The KIT-B Conversion Package "**BC14B**" includes all the components of **Device #9** to meet current Chlorine Institute specifications.

PART# BC14B

CAP SCREW 9C1 (Replacing Cap Screw 9C)

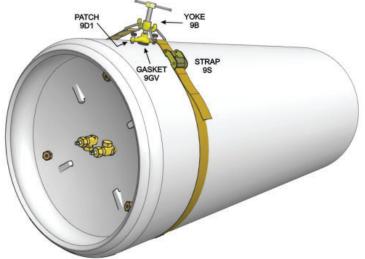
• Designed to be "hand tightened" but accessible with the standard valve wrench as well.
